**ADDENDUM # 4****Renovation of Commons A**

WBA 21-034.01

**TO: All Bidders****DATE: 30 January 2023**

**Renovation of Commons Building A**  
**BID SET**  
Tuskegee University  
Benjamin F. Payton Drive, Tuskegee, AL 36088  
21-034.01

3 UNIT B-ALT - POWER & AUXILIARY  
1/4" = 1'-0"

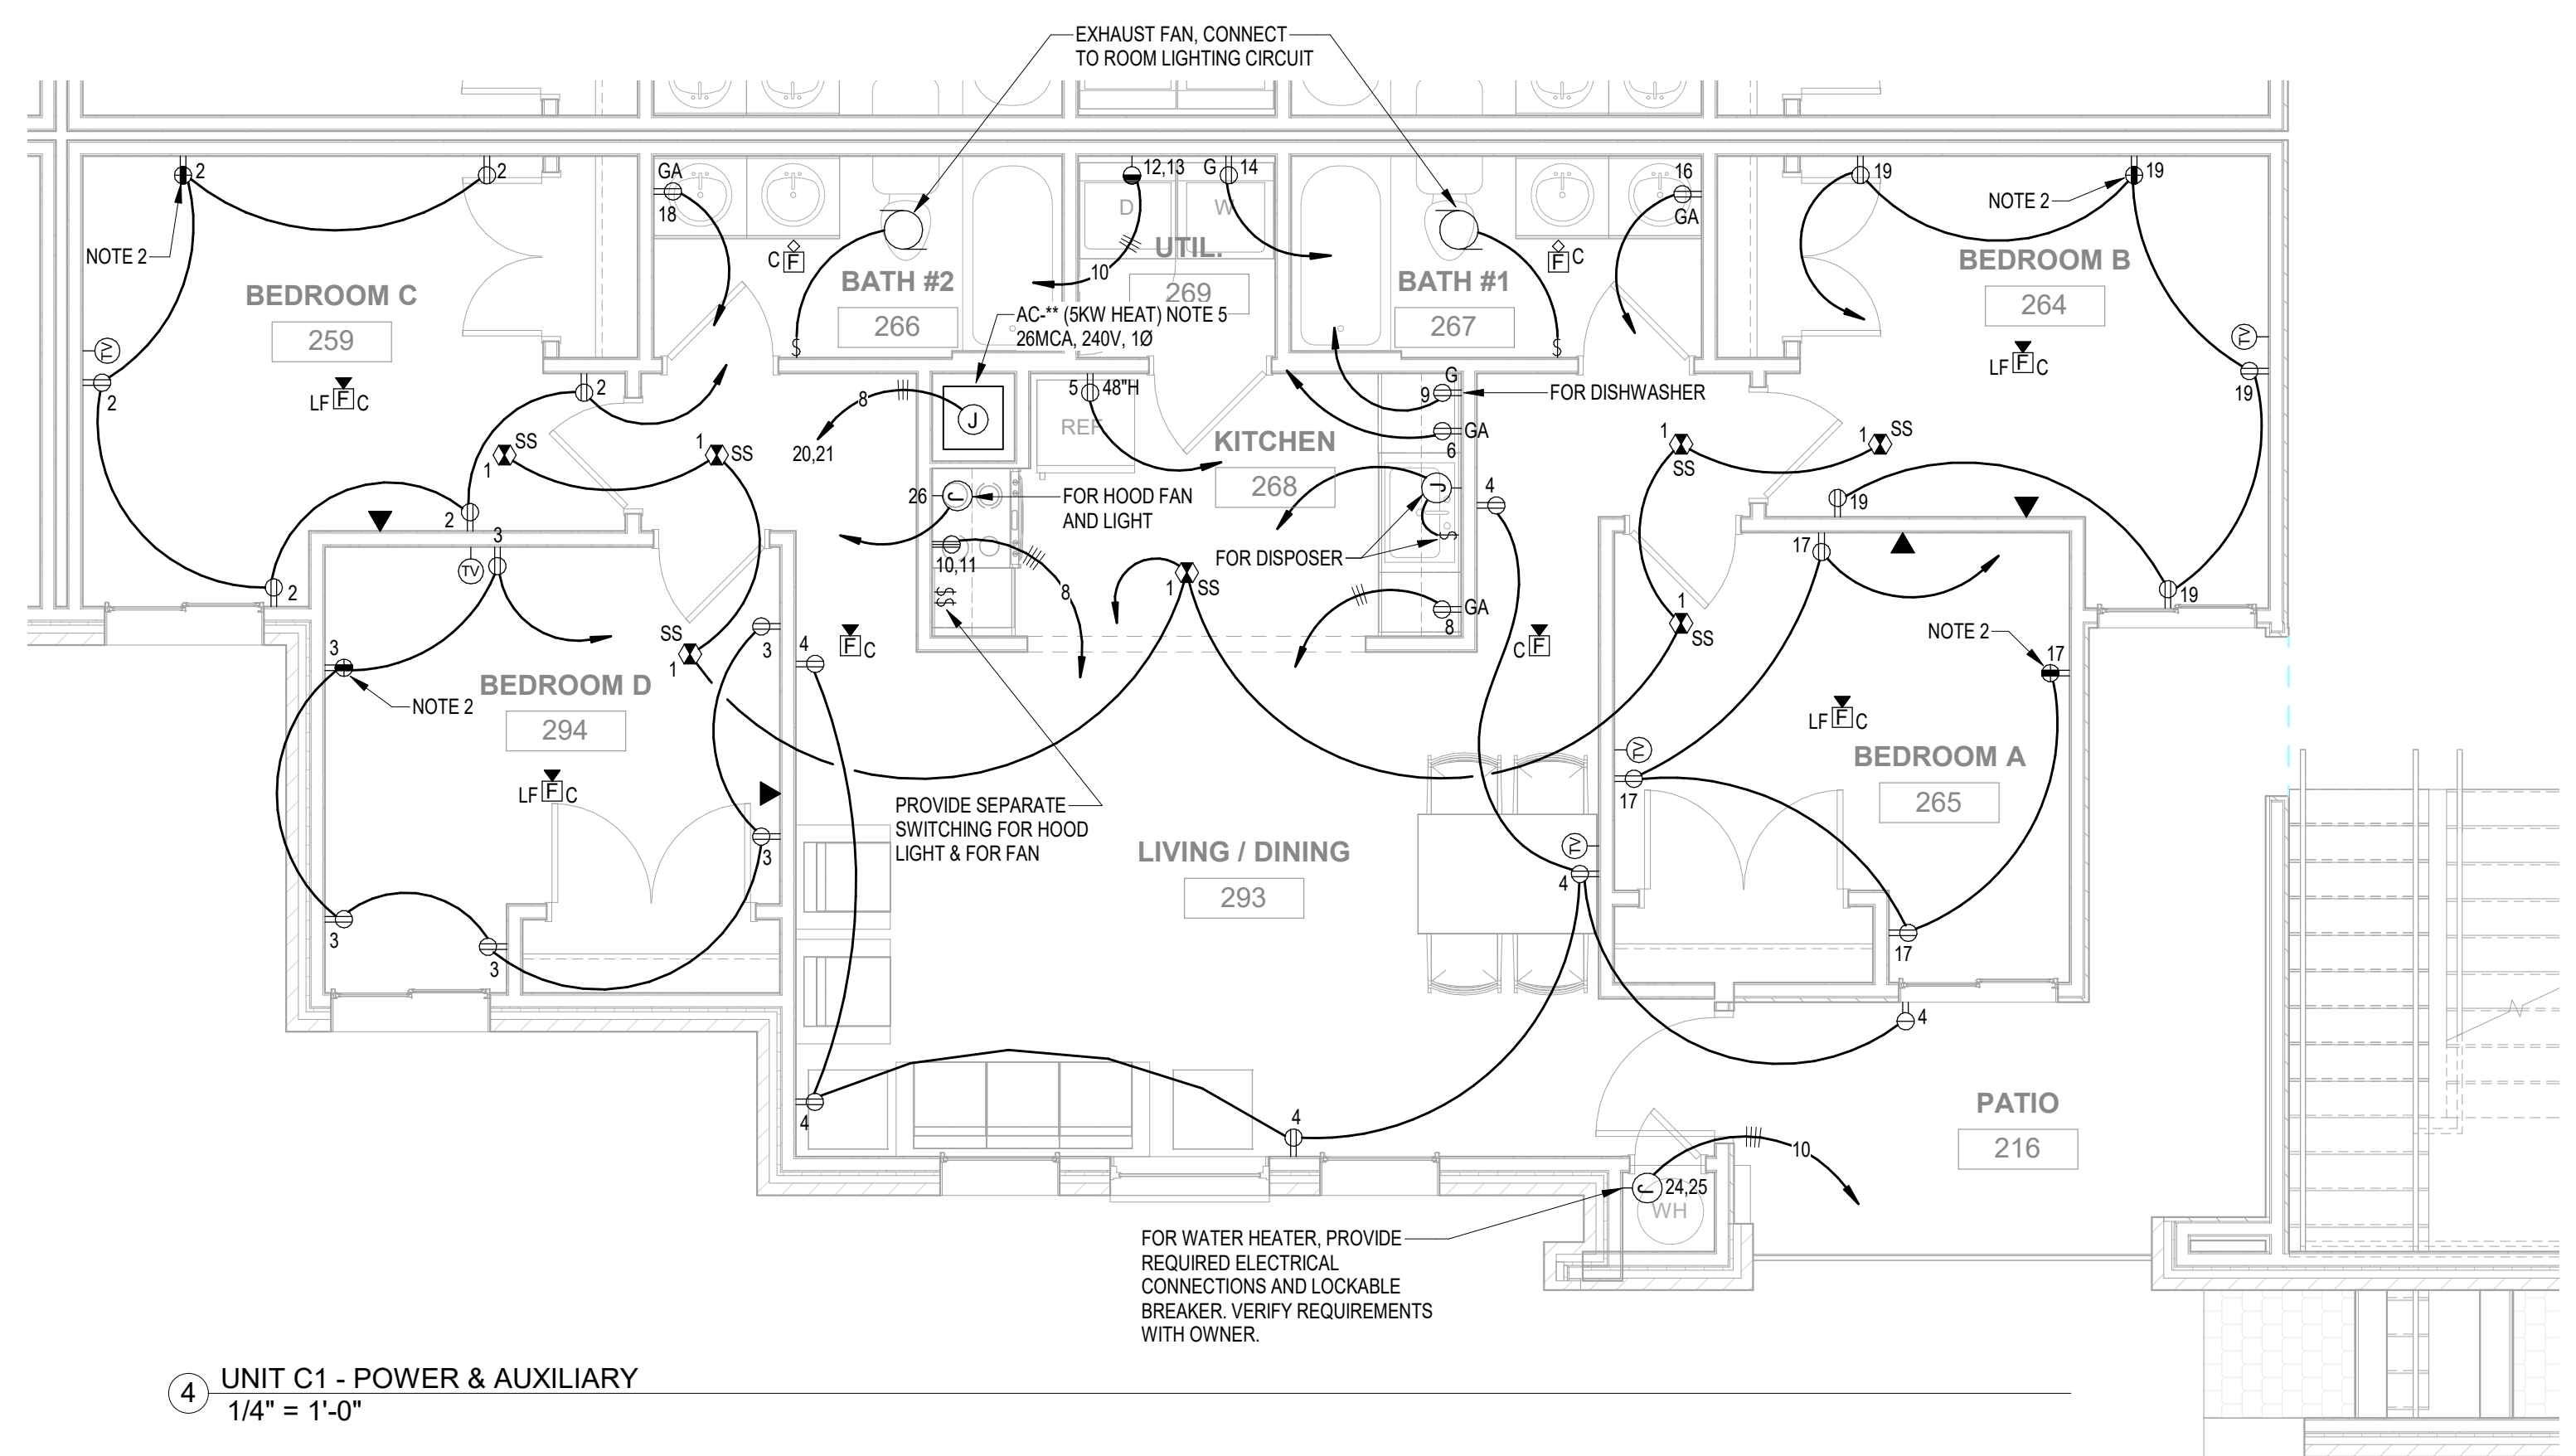
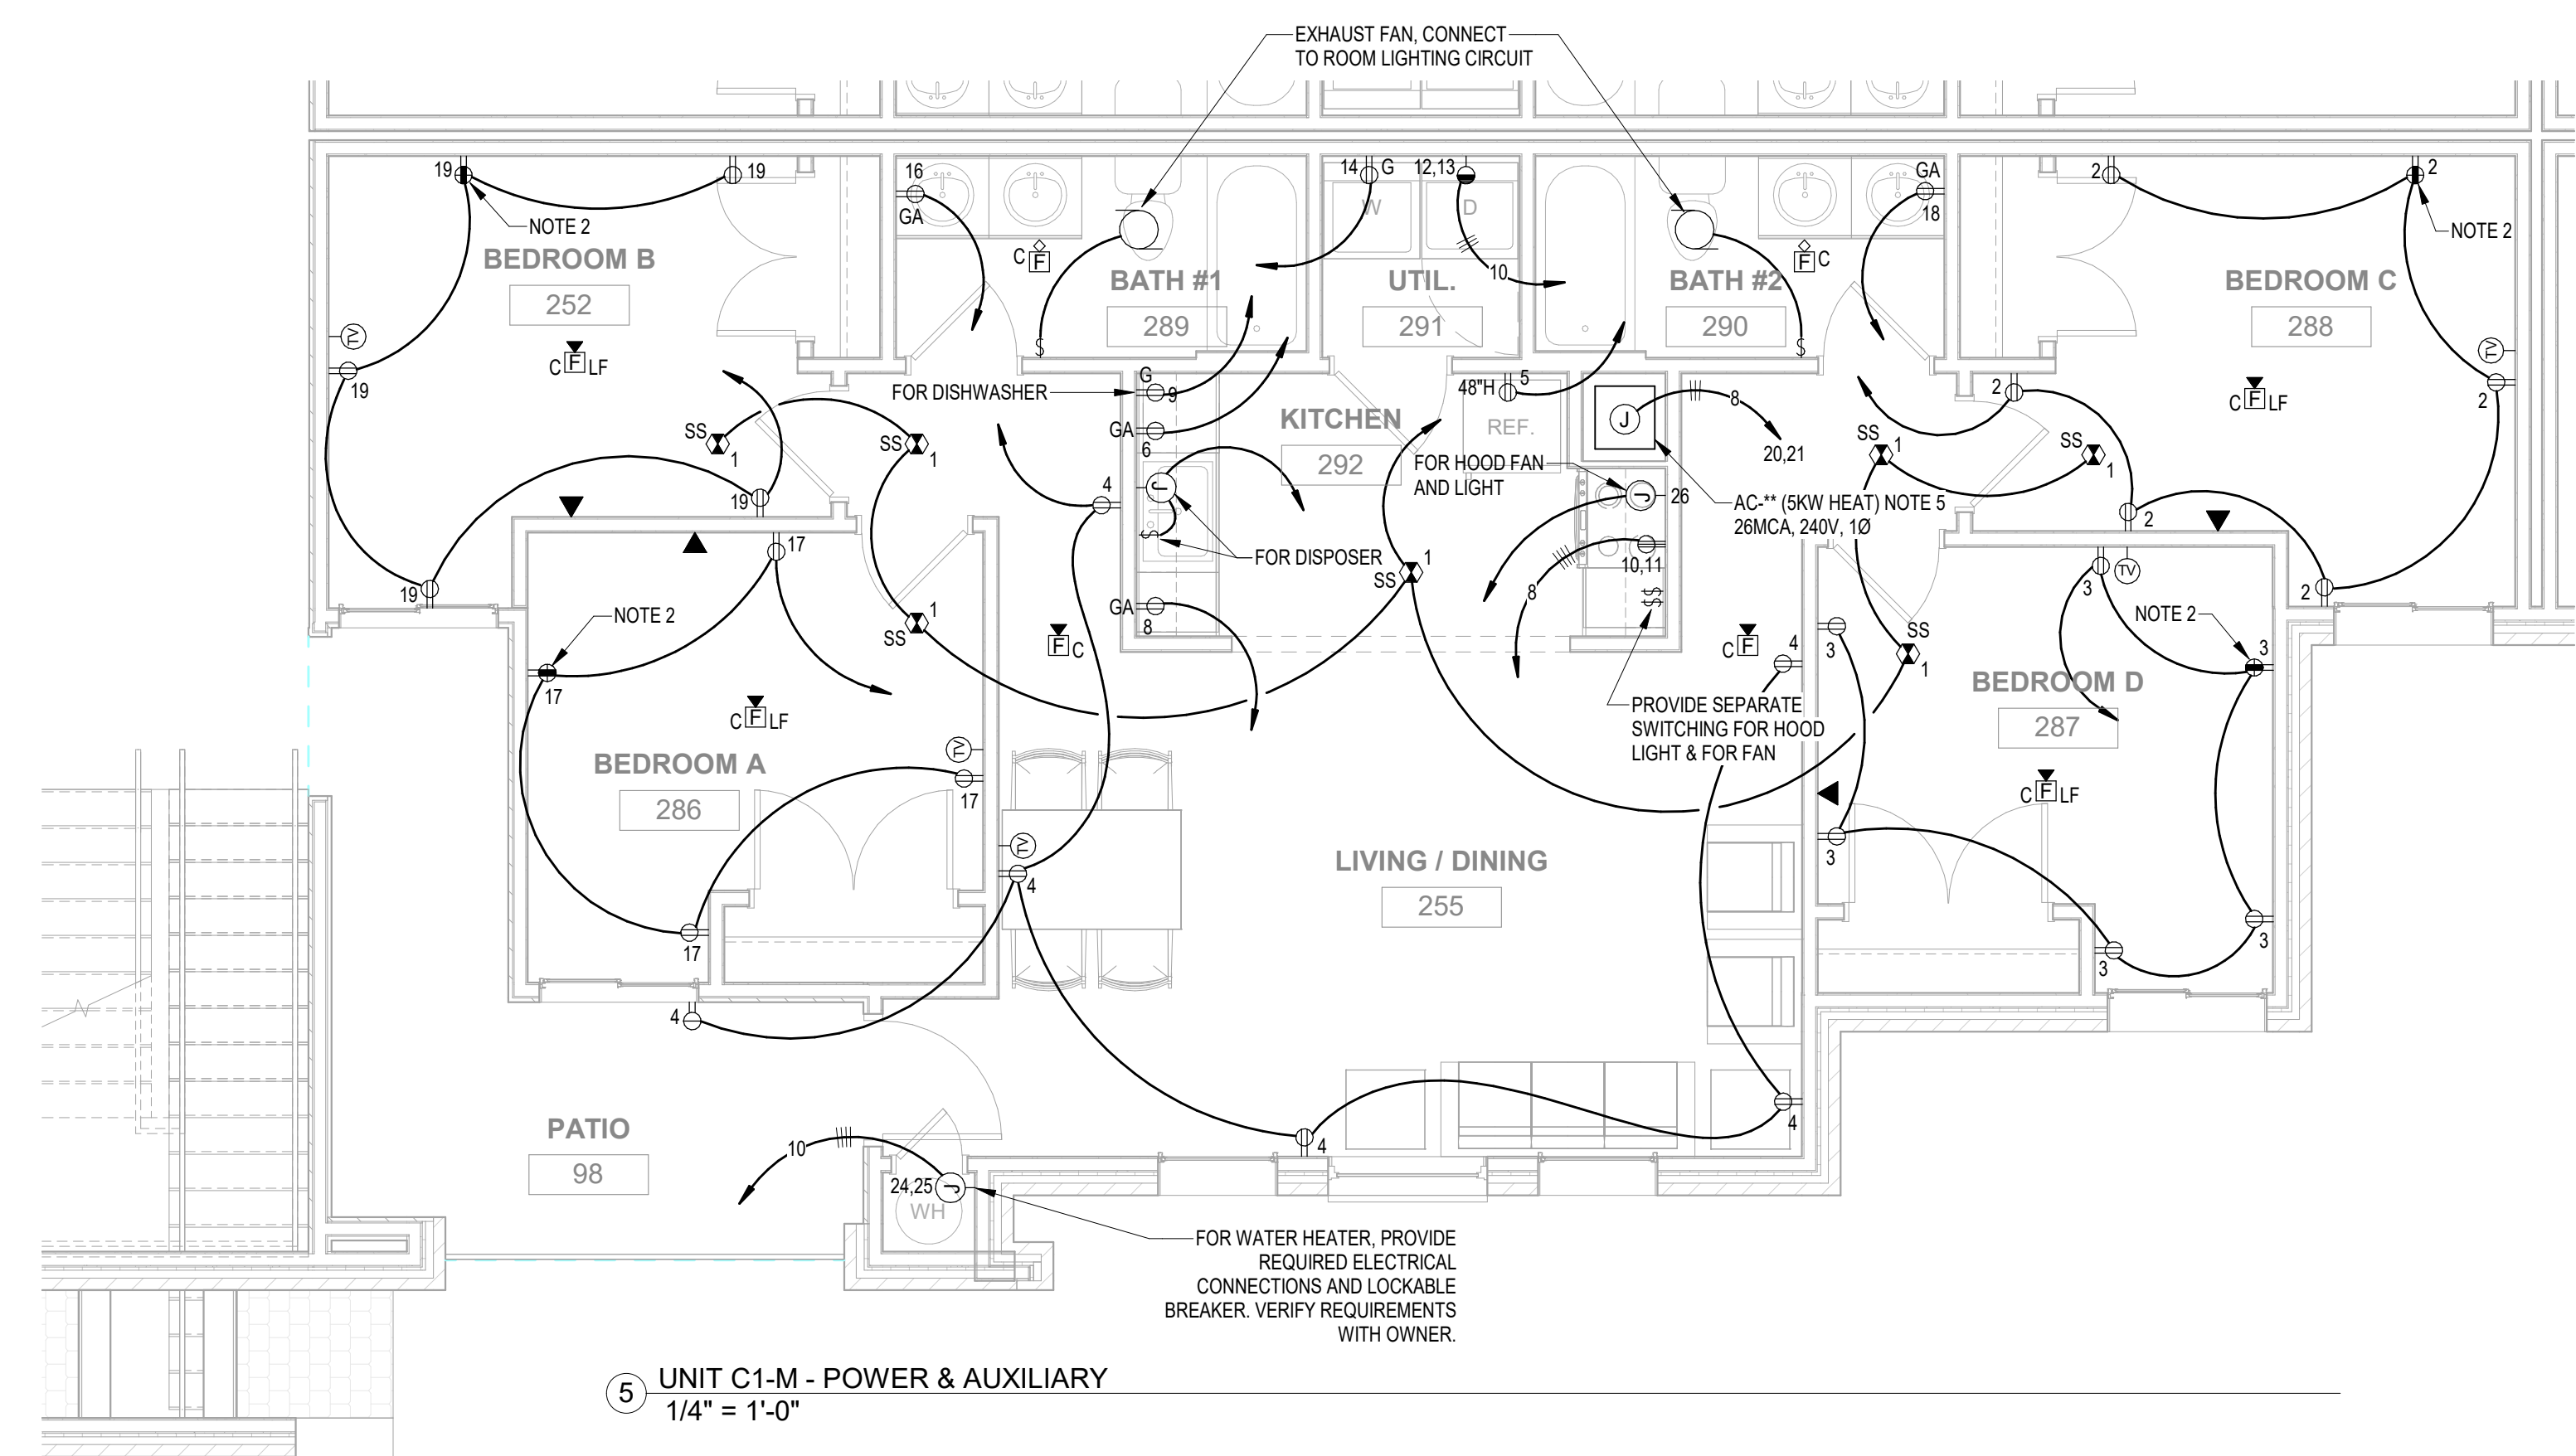
7. Sheet E5.2 – Revised device mounting heights to incorporate DCM review comments.
8. Sheets P001/P101/P102/P103 – North arrow and graphic scales were added, additionally riser diagram of the hot and cold water piping were added to incorporate DCM review comments.
